Approval no: DEV2019/1054

MNCE Ref: C3301

SITE BASED STORMWATER MANAGEMENT PLAN

221 Teviot Road, Greenbank

Figure 1.2: Verge Details

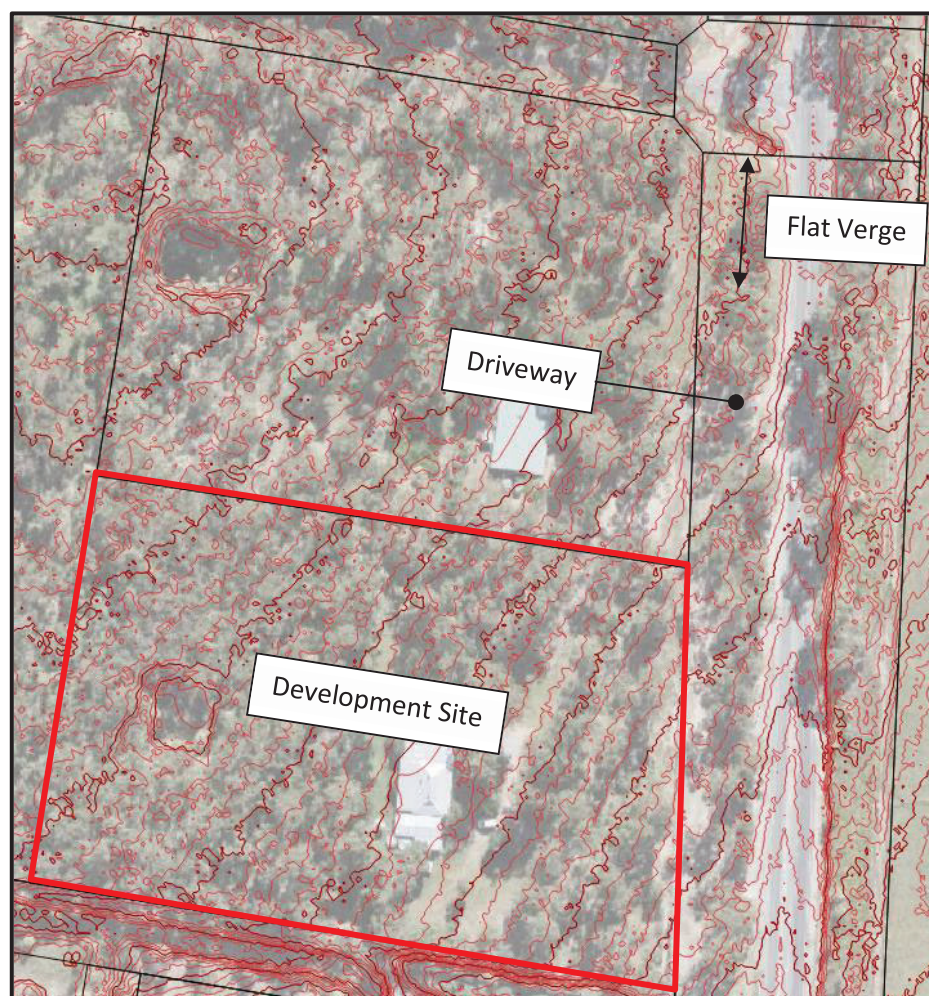
- The deceleration lane in Teviot Road (with K&C) and proposed driveway crossover will direct significant external flows down the internal driveway. Provide details of how this external catchment will be managed in the design.

A proposed swale drain was requested to direct flow from the proposed deceleration lane in a northerly direction to discharge to existing table drain in Leanne Court by John Atkinson, Economic Development Queensland Engineer.

A proposed swale however is not envisaged to achieve gravity discharge to the Leanne Court table drain owing to natural contours fronting the neighbouring property 205-219 Teviot Road. As can be seen below figure, there is 35m portion of verge that is flat, hence any proposed swale through this area is envisaged to be too deep to discharge into the existing table drain invert within Leanne Court Teviot Road intersection, especially considering the swale has to be deep enough to accommodate a pipe (with cover) under the immediate upstream rural driveway, flow, freeboard, and fall through this flat section of verge.

Alternately then, runoff from the proposed deceleration lane is to sheet flow through the site per existing conditions. The additional runoff generated from the change in pervious to impervious area of the deceleration lane has been found to be negligible. Based on a Rational Method calculation utilising a catchment of 0.037ha, a time of concentration of 25 mins to the rear neighbouring property, an existing C10 of 0.70 and a proposed C10 of 0.88, runoff was found to increase 1L/s, 2L/s, 2L/s, 3L/s, and 2L/s in the 39%, 10%, 5%, 2%, and 1% storm event respectively, which can be generally offset by the difference in flow rates between existing and mitigated conditions, refer Section 5.7.
